ADDENDUM 03 SOFTBALL UPGRADES

Date: Monday, December 8, 2025

Project #: 0323.25.002

Project Name: Softball Upgrades
Vicksburg High School – 3701 Drummond St., Vicksburg, MS 39180
Warren Central High School – 1000 MS-27, Vicksburg, MS 39180

1 PRESS BOX/ CONCESSION ELEV 1
1/4" = 1'-0"

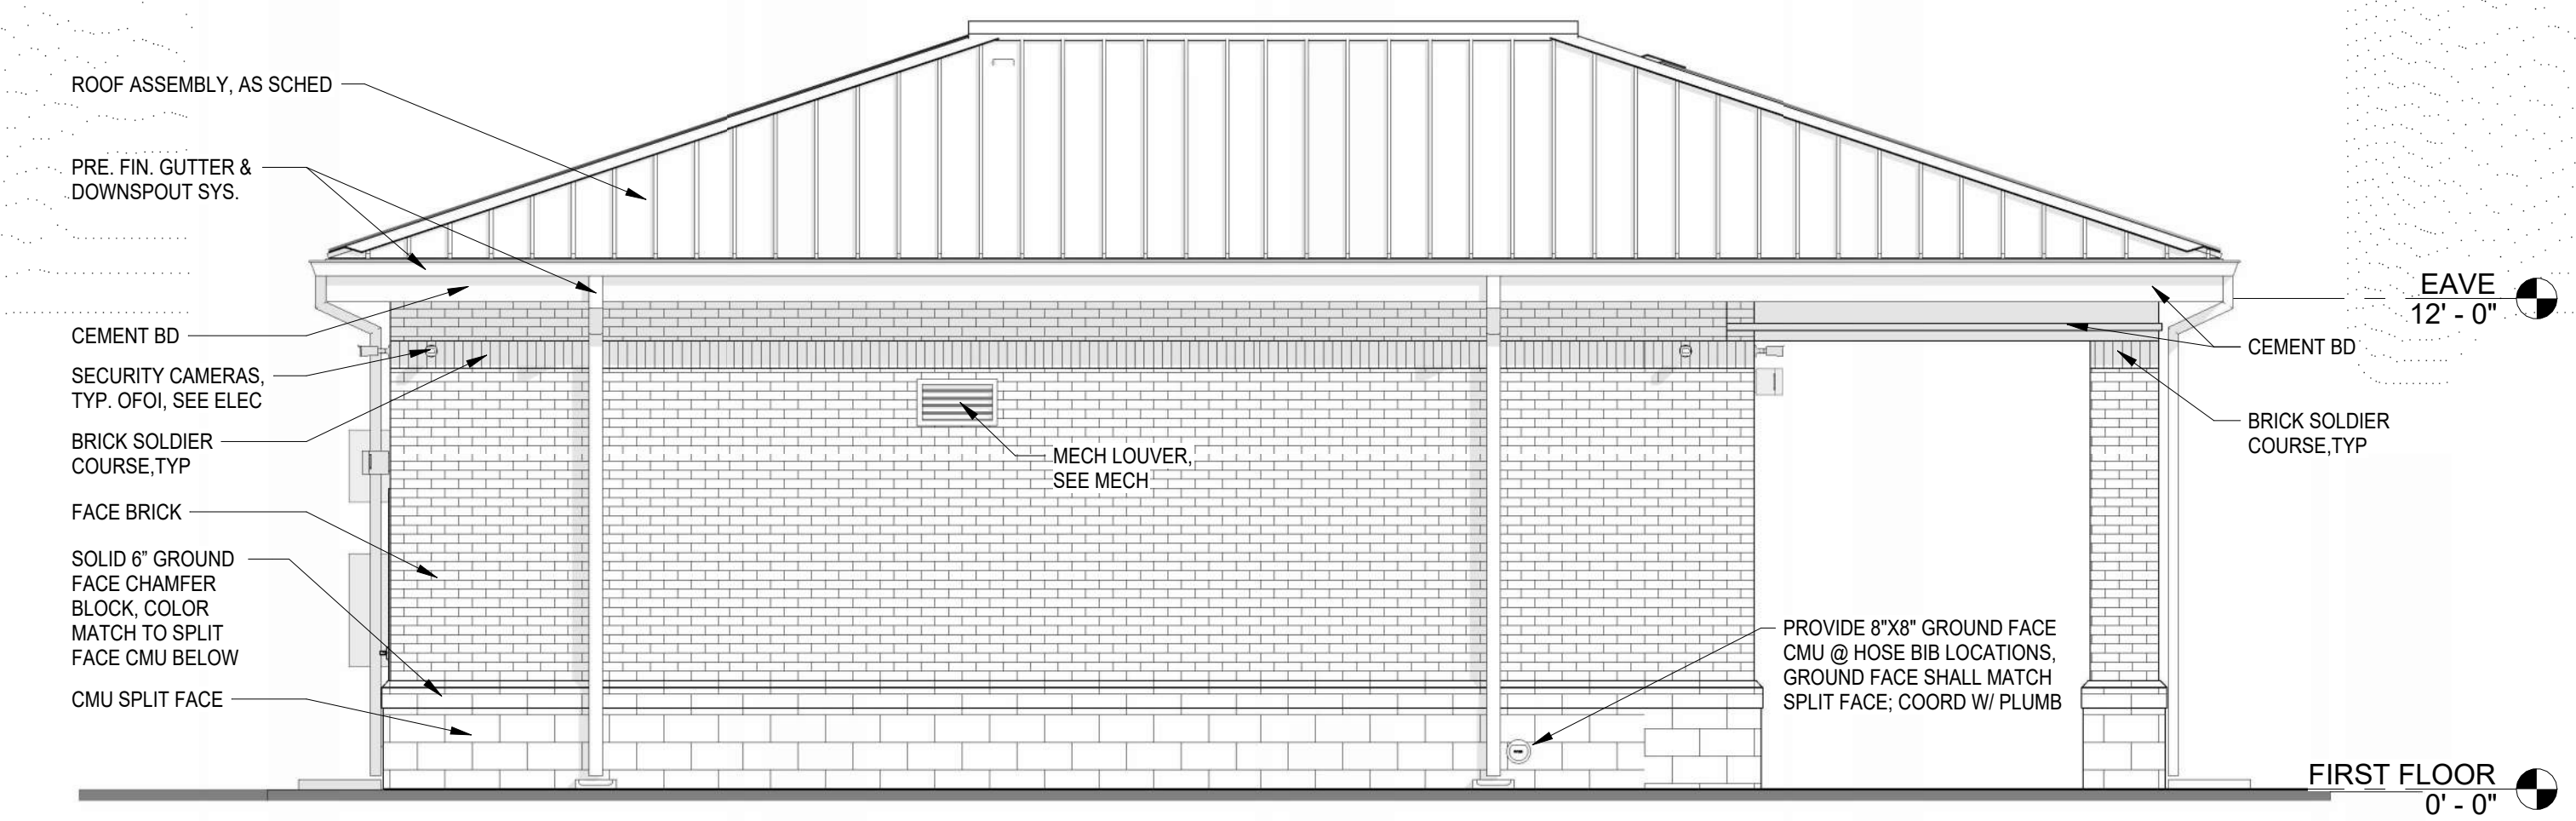
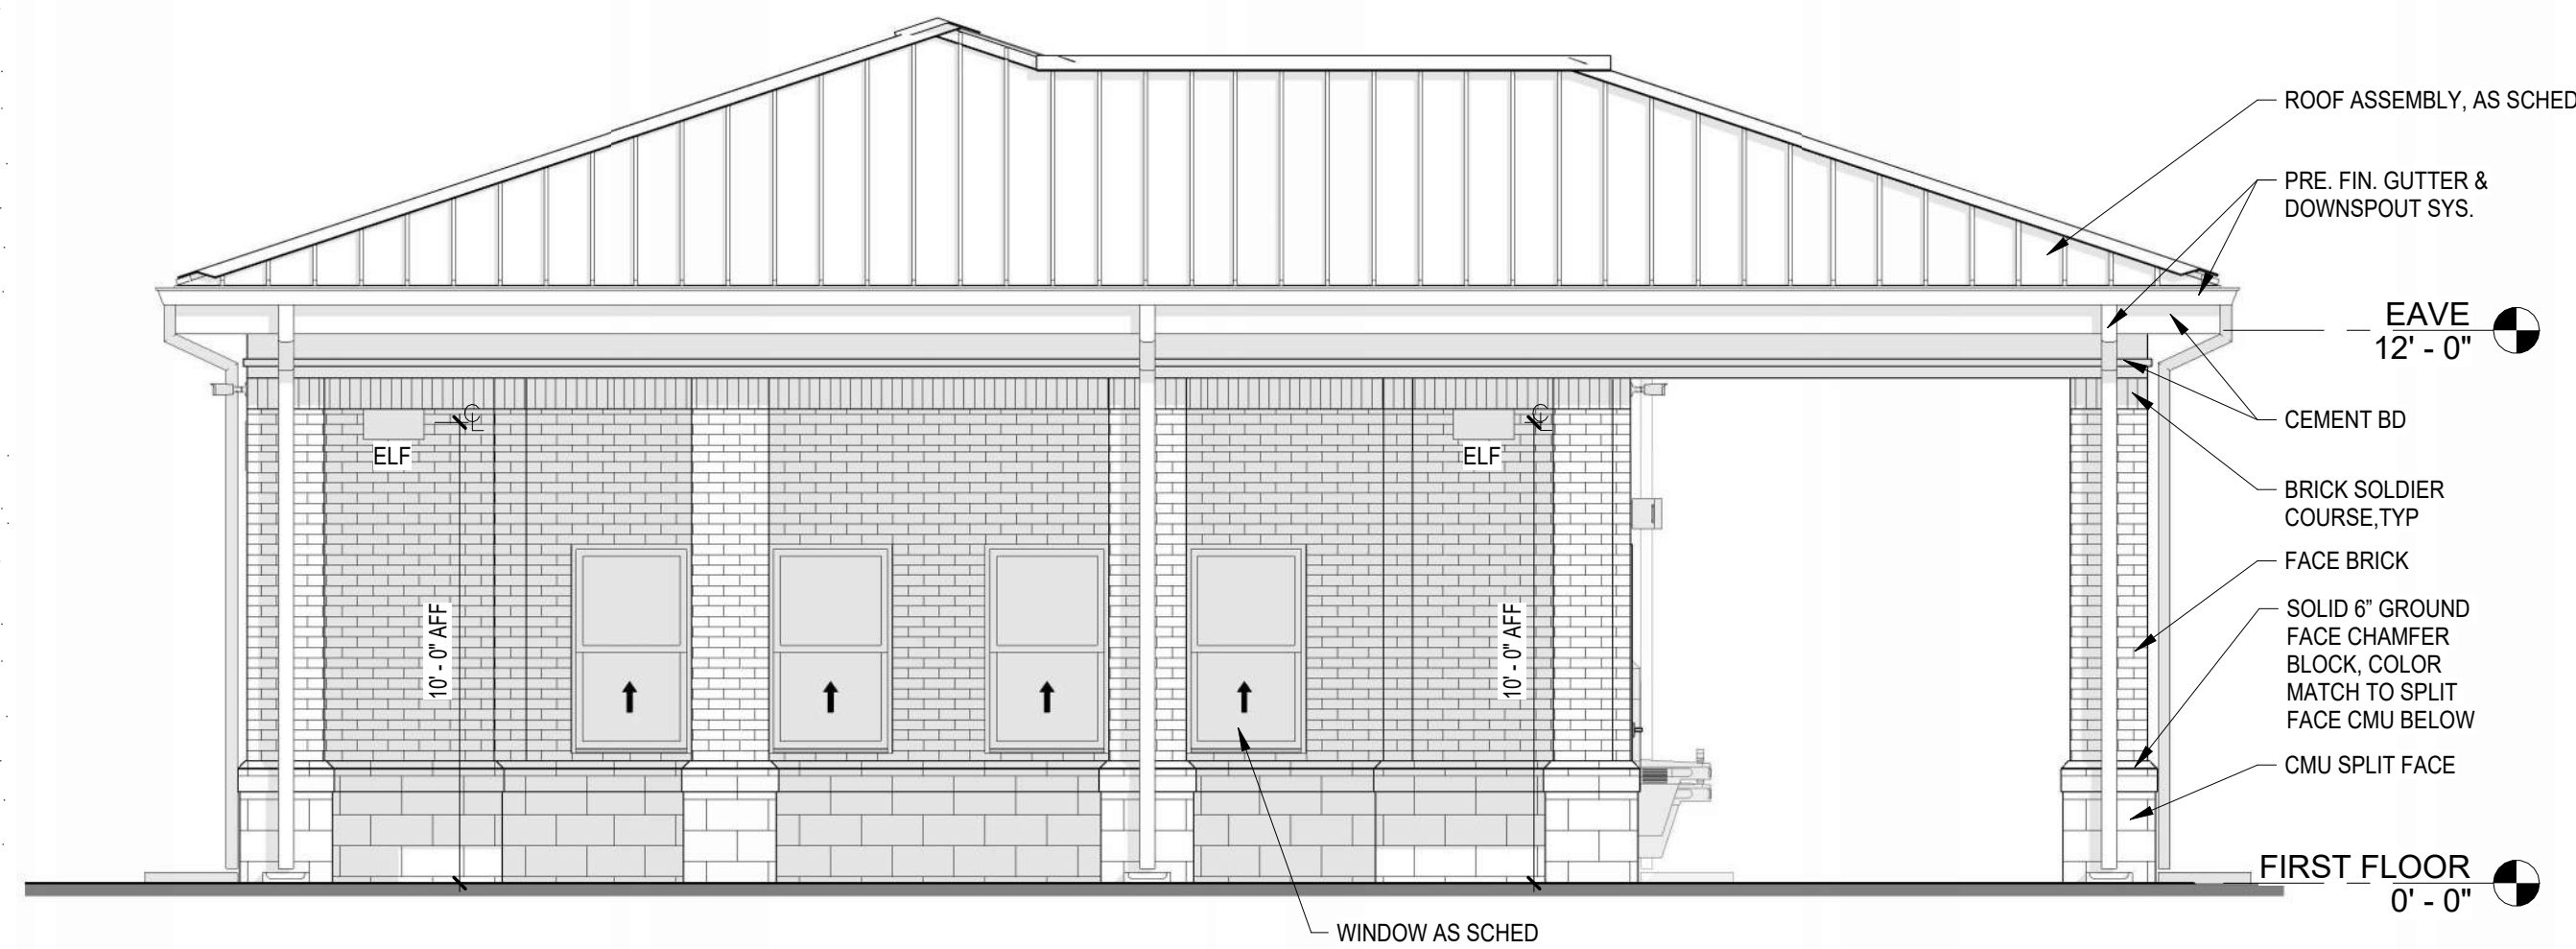
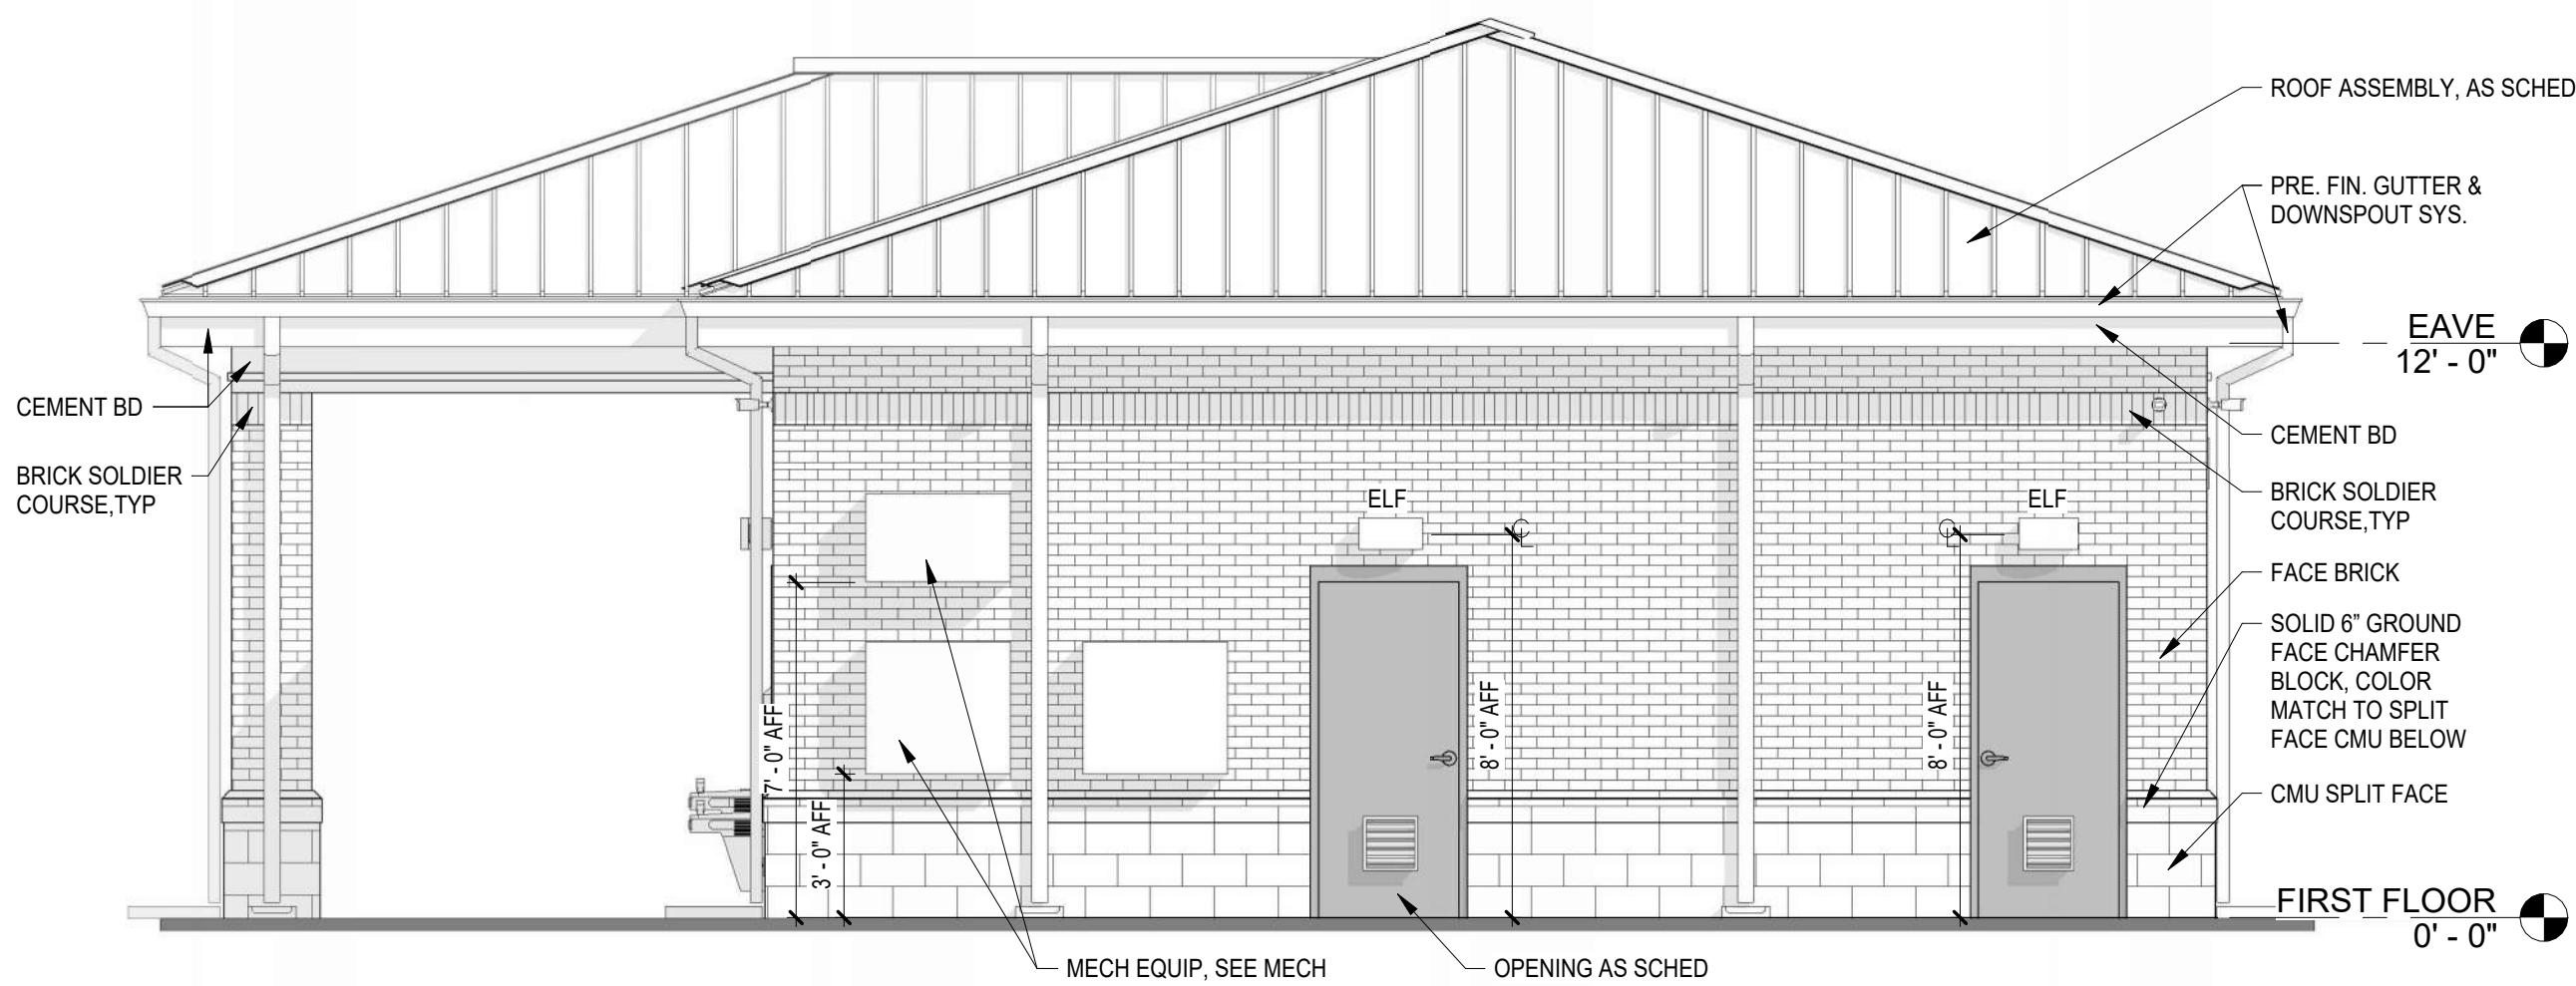
- B4. Please clarify the exterior finish for the downspout and gutters. **Match the metal roof color. Exterior Finish materials have been added to the exterior elevations in the attached revised drawings.**
- B5. Can you Provide specifications for the metal liner panel on A310/ 1 &2. **There is no interior metal liner panel. The metal soffit has been corrected to the bead board cementitious soffit.**
- B6. Page E611 it shows 7 speakers at various locations. The site layout only show speaker at A1 & A2 bleacher locations needing only 2 speakers. Am I missing something? **The other speakers are on top of the press box. See sheets E142 and E143 specific note 6. Do note the sound system applies to both VHS and WCHS Softball Fields.**

1. ROOF, DOWNSPOUTS, STOREFRONT, SOFFIT, & GUTTERS: MBCI- MIDNIGHT BLACK.
2. CEMENT BOARD TRIM & DOOR PAINT: SW 7521 PAVILION BEIGE (PAINT TO MATCH SPLIT FACE COLOR).
3. COUNTERTOPS: BLACK PEARL GRANITE.
4. SPLIT FACE & SOLID UNIT: BLOCK USA- HERITAGE BEIGE.
5. FACE BRICK: WATSONTOWN BRICK- MEDIUM GREY WIRECUT.
6. MORTAR: HOLCIM- 200N.
7. STANDARD PRE FIN AWNINGS WITH HANGER RODS: AWNING AND ROSE MIDNIGHT BLACK.
8. STRUCTURAL GRID/ COLUMN LINES NOT SHOW FOR CLARITY. SEE FLOOR PLANS AND BUILDING SECTION FOR STRUCTURAL GRID/ COLUMN LINES.
